SERVICE BULLETIN

BULLETIN NUMBER: 276

SUBJECT: Generator Drive Belt Performance

AFFECTED: 3.5 SBCG and 3.0 BCG Gasoline Generators

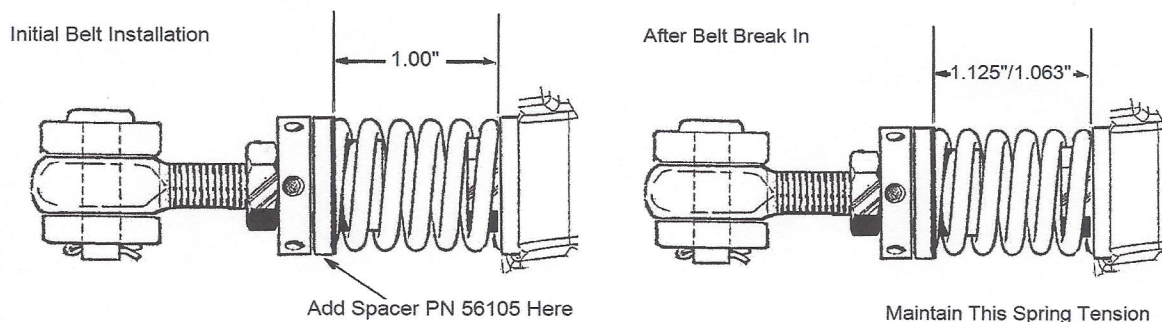
DETAIL: Generator drive belt performance improvements include a belt tension adjustment change, the addition of a spring spacer, and a new idler pulley. 3.5 SBCG generators produced on or after manufacturing date code OD (April 2015) will have these changes. Changes made are enhancements, modification to existing products is not covered under warranty.

Manufacturing of new products includes, for optimum and rapid belt break in, adjusting the belt tension spring to 1.00" in our assembly process as illustrated below. After the first hour of run time, if necessary, it is readjusted to 1.00" prior to releasing the unit for shipment.

Important Note: Maximum performance of the drive belt and prevention of potential failure due to incorrect tension requires maintaining the belt tension spring to maximum 1.125" and minimum 1.063" at the recommended first 50 hour maintenance interval.

Generator drive belts sold for regular maintenance replacement part numbers change to 56107 for 60HZ and 56108 for 50HZ and they are a kit with instructions that includes the required spring spacer. Replacing the pulley is not required. Initial adjustment of the belt with the spacer installed is 1.00". After running the unit for 1 hour varying AC loads, the belt must be adjusted again to 1.00". After 50 hours run time, or during the next scheduled service, inspection and adjustment to 1.125" to 1.063" is required for proper belt tension.
